APPLICATION FOR SUBMITTAL OF POST-APPROVAL DOCUMENT

School District/Owner: San Rafael City Schools	DSA File Number: 21 H1
Project Name/School: Terra Linda HS Shade Structure & Entry Canopy	DSA Application Number 01 120767

Dust collector replacement.

(RFP 001.1)

SITE PLAN - ELECTRICAL

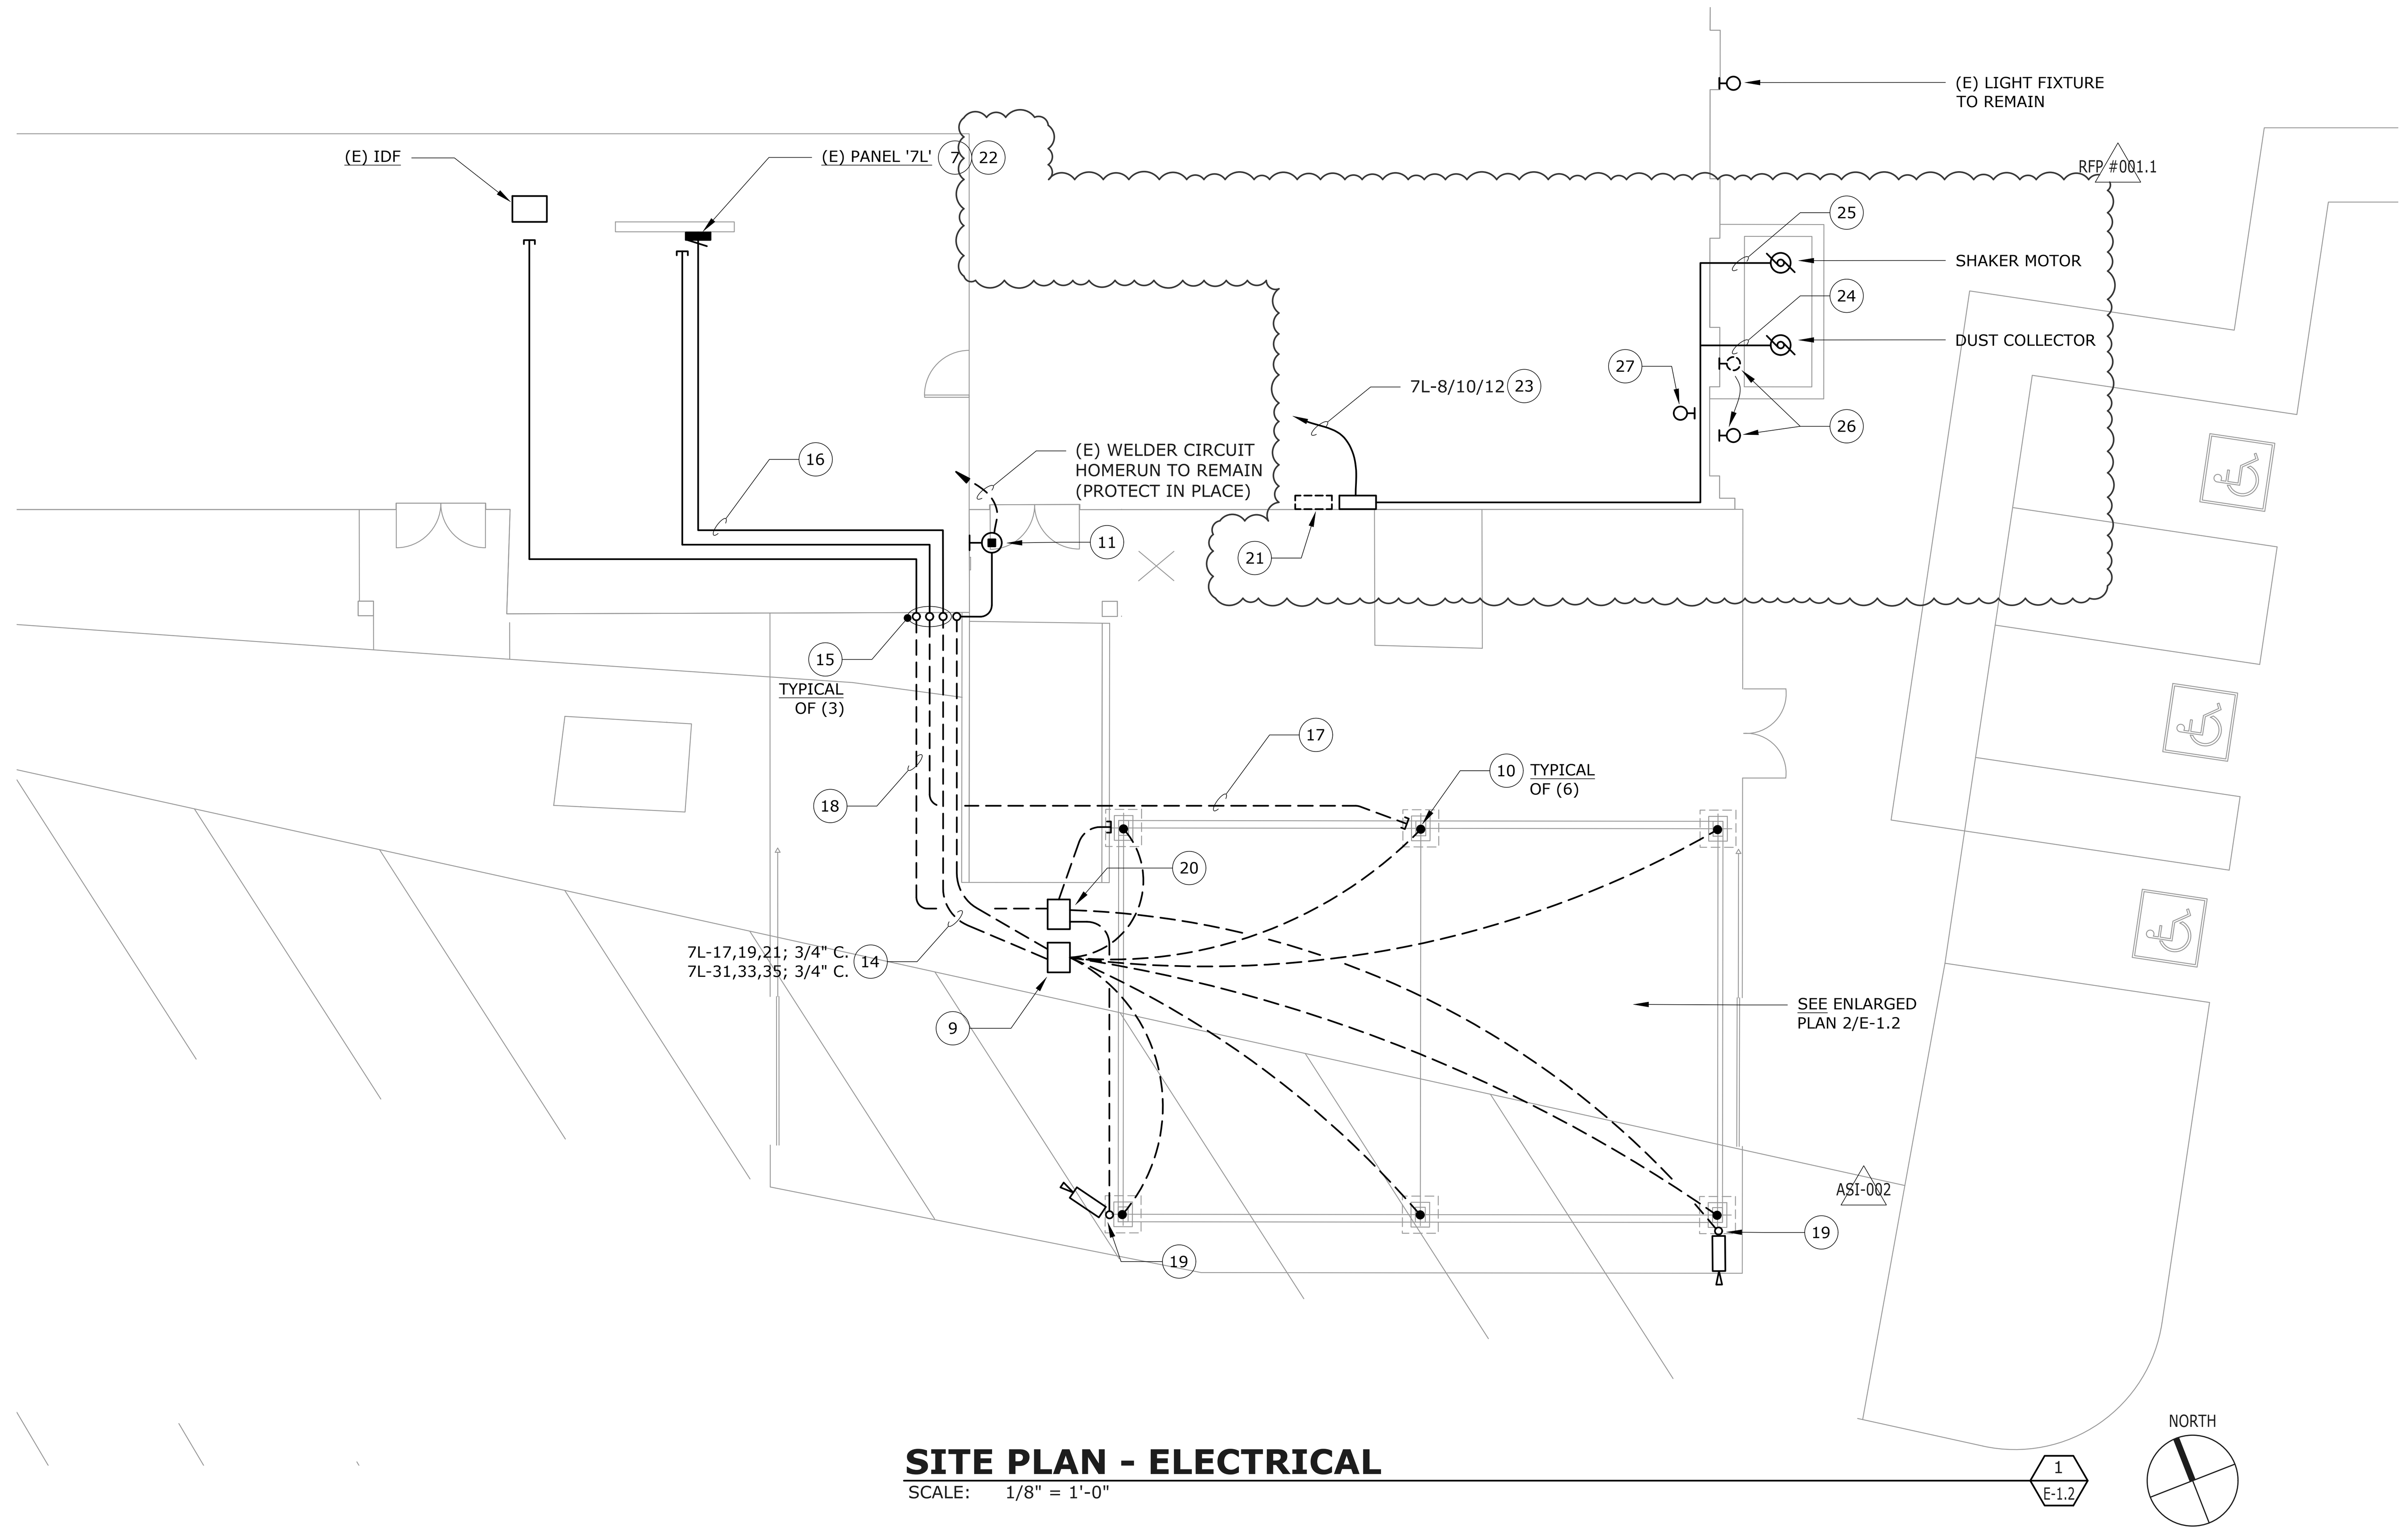
20. FLUSH IN-GROUND CHRISTY #N9 OR EQUAL, WITH TRAFFIC RATED H20 STEEL COVER LABELED "SIGNAL". ASI-002
21. DISCONNECT AND REMOVE (E) DUST COLLECTOR CONTROL PANEL AT INTERIOR CLASSROOM, INCLUDING (E) 20A, 3-PHASE CIRCUIT BACK TO PANEL 7L-8/10/12 AND OUT TO (E) MOTOR.

22. REPLACE (E) 20A/3P BREAKER AT POSITION 8/10/12 WITH (N) 60A/3P BREAKER. (N) BREAKER TO MATCH (E) IN MFGR. AND AIC RATING (EATON / 10KAIC).
23. CONNECT COMPLETE TO (N) DUST COLLECTOR CONTROL PANEL (BY DIV 23) AND PROVIDE AND INSTALL (N) 1" C. HOMERUN WITH (3)#4+(1)#10G TO PANEL 7L-8/10/12.

24. PROVIDE AND INSTALL (N) 1"C. WITH (3)#4+(1)#10G FROM CONTROL PANEL TO 15HP(208V) DUST COLLECTOR MOTOR. DISCONNECT AT DUST COLLECTOR PROVIDED BY DIV. 23, PER SHEET M-1.0, INSTALLED BY DIV. 26.

25. PROVIDE AND INSTALL (N) 1/2"C. WITH (3)#12+(1)#120G FROM CONTROL PANEL TO 3/4HP(208V) SHAKER MOTOR. DISCONNECT AT SHAKER MOTOR PROVIDED BY DIV. 23, PER SHEET M-1.0, INSTALLED BY DIV. 26.
